Service Bulletin No.1005

MODEL	: T2140 & T2145
TYPE	: Service information
MANUAL & SECTION	: Maintenance Manual: Chapter 9 - Electrical system
DATE	: November 14th, 1997
SUBJECT	: Front heater fresh air flap electrical circuit
CONDITIONS	: Service information only.

Figure 1: Right hand side main junction box

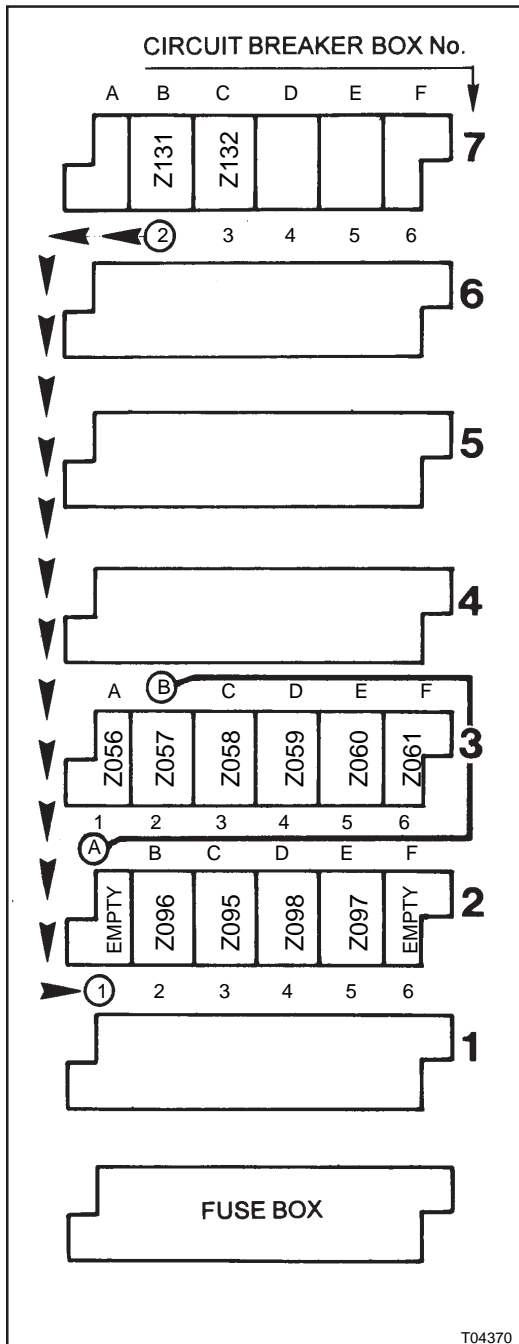
1. Remove 8 amp circuit breaker Z132 from slot No.3 in circuit breaker box No.7.
2. Insert the circuit breaker in empty slot No.1 next to circuit breaker Z096 (circuit breaker box No.2).
3. Delete text "Z131" on label next to circuit breaker box No.7. Enter text "Z065" on label next to circuit breaker box No.2.
4. Remove the second connector from the back of circuit breaker box No.7 and remove the blue/green wire (see also Maintenance Manual, Chapter 9 under heading "Electric Connectors"). Put the connector back.

5. Remove the first connector from the back of circuit breaker box No.2. Put the terminal of the blue/green wire in slot No.1 of the connector. Install 5" of 16 AWG jumper wire in slot A. Put the connector back.
6. Remove the first connector from the back of circuit breaker box No.3. Put the terminal of the jumper wire in slot B of the connector. Put the connector back.

Figure 2: Terminal of switch S112

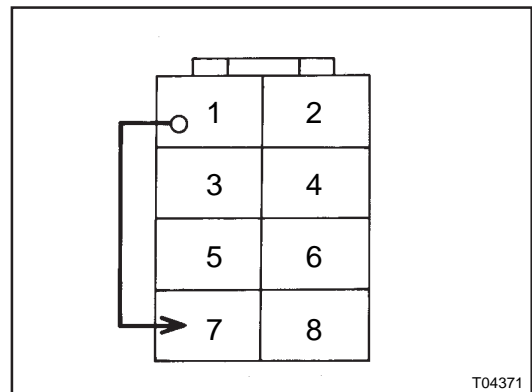
1. Dislodge the defroster fresh air intake switch, pull it out of the instrument panel and remove the connector.
2. Looking at the open end of the connector, remove the terminal of the yellow and blue wire from slot No.1 (see figure 2) and insert it in slot No.7.
3. Refit the connector to the switch and reinstall the switch. Reconnect the batteries.
